**SERVICE BULLETIN**

**SB049-0399**

Subject: Lancair Main Gear Hydraulic Cylinder (Lancair IV, IV -P)

Date: 15 March, 1999

**Figure 1.**

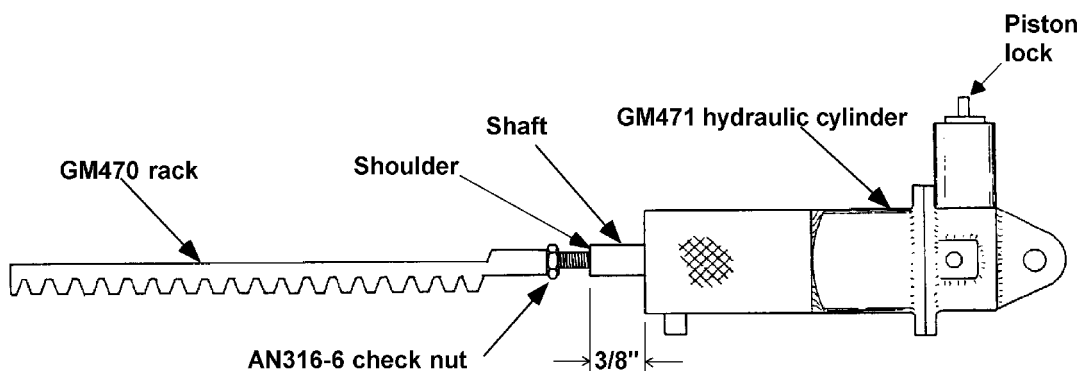
With the aircraft sitting on its gear, accurately measure the length of the shaft between the cylinder housing and the shoulder where the threads begin. It should be  $3/8$ ". If so, no further action is required. Recheck this length every 100 hrs.

**Figure 2.**

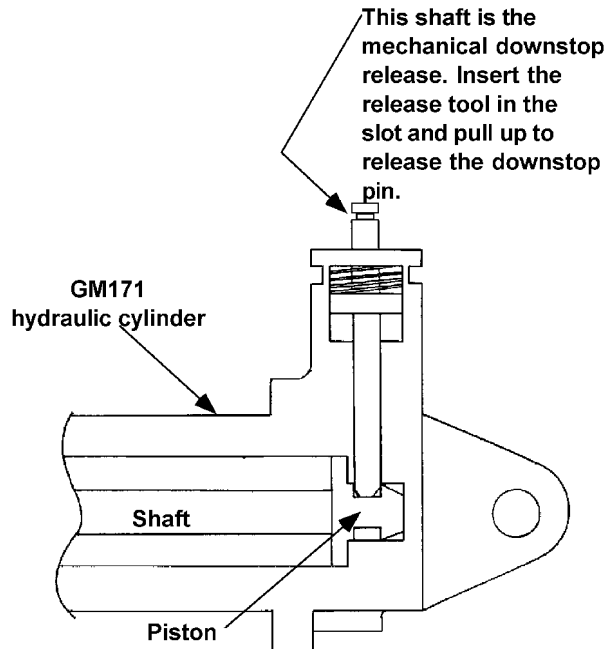
If this distance between the cylinder housing and the shoulder is more than  $3/8$ " and less than  $7/16$ ", support the aircraft on jack stands and release accumulated pressure in the hydraulic system by operating the flaps. Refer to manual pages 19 -77 through 19-79. Check that the piston is bottomed out and the down lock is engaged.

When the downlock is engaged, the gear should remain very near the downstop cushion and not drop away when hydraulic pressure is released. Manually pull down and back on the gear to make sure. Push the gear forward into the cushion and support it in position to make sure the piston is bottomed out. Recheck the measured distance between the cylinder housing and the rack as well as the housing to shoulder distance. Release the check nut on the cylinder shaft and turn the shaft, attempting to thread it into the cylinder and out of the rack. Check the measured distances again. If the housing/shoulder distance remains the same and the housing/rack distance increases, the piston is secured to the shaft and no action is necessary. Recheck every 100 hrs. If the housing/shoulder distance decreases and the housing/rack distance stays the same, remove the cylinder and ship it to Lancair for repair.
